INDESIT company

Model type:
WI62EX

Commercial code:
F030505

Notices

n1040376: Drain pump with filter with pin.

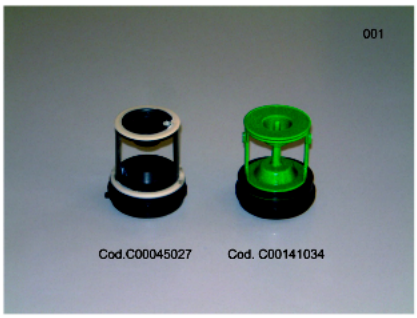
A new drain pump with filter with pin has been introduced progressively as from serial no. 50609.0001.

New parts:
C00119307 - Drain pump with pin filter;
C00141034 - Askoll / Plaset drain pump with pin filter kit (figure 001);

Premodification parts:
C00092264 - Drain pump;
C00045027 - Askoll / Plaset pump filter kit (figure 001);

The new parts can be used on all WASHING MACHINES previously equipped with the premodification parts.
